SERVICE BULLETIN **Buell**[®]

B-024B

SAFETY RECALL CODE 0817 - REVISED SHOCK EYE

Figure 2. New Shock Absorber Assembly

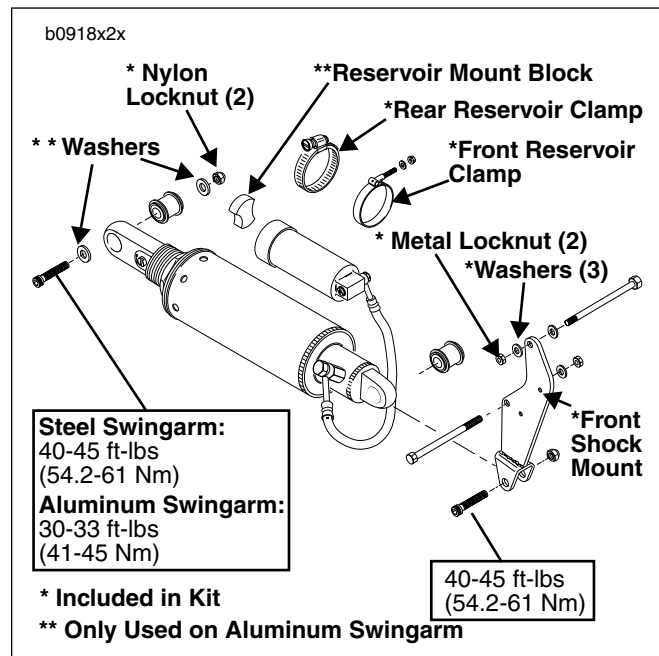
Since the release of the original bulletin (B-024), Buell Motorcycle Company has released a **new** shock absorber. This revised recall procedure applies to affected motorcycles that did not have the initial 0817 recall service performed. For motorcycles that have had the original 0817 recall service performed, refer to Bulletin B-035 for installation instructions.

The new front shock mount **MUST** be used with the new shock absorber. The new shock is 1.77 in. (45 mm) shorter than the previous shocks and requires the new front mount to align and install properly.

1. See Figure 2. Install **new** front shock mount to crankcase with two **new** front shock mount bolts, washers, star washer (on 1997 M2, S3/S3T models only) and metal locknuts. Tighten bolts to 30-33 ft-lbs (41-45 Nm). **NOTE:** Top bolt goes in from the left side, bottom bolt goes in from right side. Bottom bolt does not use washer under bolt head. Star washer (only used on 1997 M2, S3/S3T models) goes on bottom bolt under the washer on the nut side. If exhaust was loosened during front shock mount removal, replace exhaust gaskets and reinstall exhaust. See appropriate Service Manual, Section 2 for instructions.

4. See Figure 2. Position **new** shock absorber from kit in mounting position.
5. Loosely install bolt, washers (aluminum swingarms only) and **new** locknut through rear shock eye and swing arm.
6. Loosely install bolt and **new** locknut through front shock eye and front shock mount.
7. **On 1996-1998 vehicles only:** Loosen header tie bar from collector.
8. Position front clamp over reservoir. Loosely install **new** front reservoir clamp to front shock mount (and install **new** header tie bar spacer between front shock mount and header tie bar on 1996-98 vehicles only) with **new** washer and **new** nylon locknut.
9. See Figure 3. Loosely install **new** rear clamp around reservoir and oil feed line.
10. **All Models:** Install **new** reservoir mount block between oil pump fitting and remote reservoir.

Figure 5. Preload and Compression Adjustments

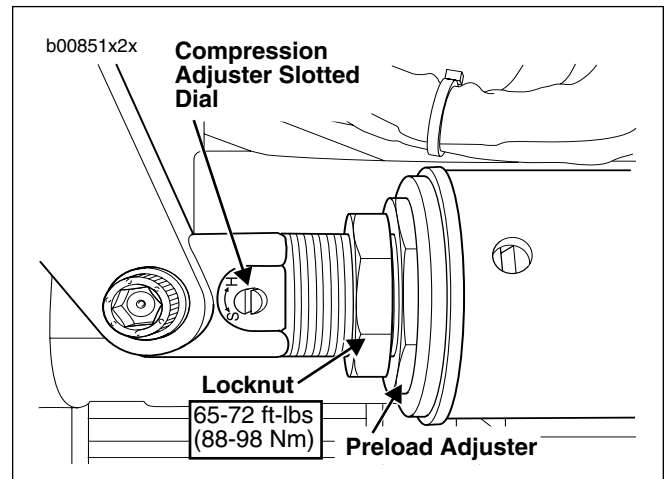
- See Figure 5. Set compression damping using the slotted dial on the shaft at the end of the shock. New factory setting is as listed below:
 - S1/S1W/M2 Models:** full damping minus 2.25 turns.

- S2/S2T Models:** full damping minus 2.5 turns.
 - S3/S3T Models:** full damping minus 2.5 turns.
 - See Figure 6. Set rebound damping using the slotted dial on the remote reservoir at the front of the shock. New factory setting is as listed below:

Figure 7. Locknut Tightening Procedure

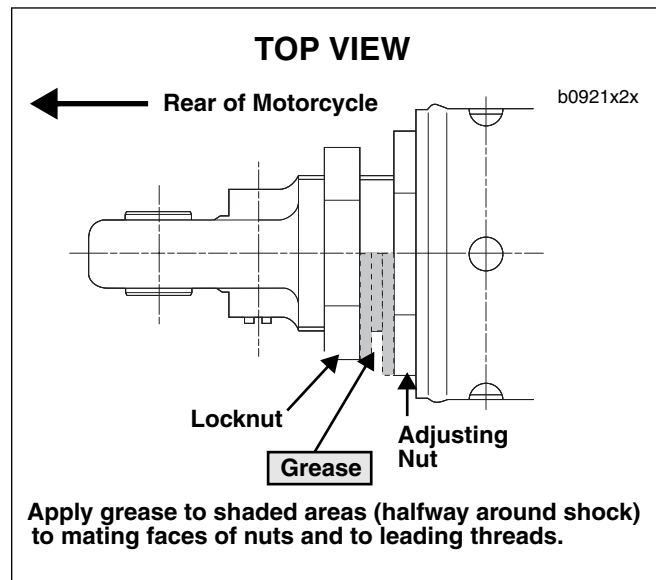
Since the release of the last bulletin (B-024A), the spring preload locknut tightening procedure has been modified (as covered in Bulletin B-037). This bulletin includes the new torque specification and tightening procedure.

- Using SHOCK PRELOAD ADJUSTING TOOLS (Part No. B-45110), hold adjusting nut in place with 60 mm ADJUSTING NUT WRENCH and tighten locknut to 65-72 ft-lbs (88-98 Nm) with 52 mm LOCKNUT CROW'S FOOT set at 90 degrees to the torque wrench.
- Wipe excess grease off of shock absorber.
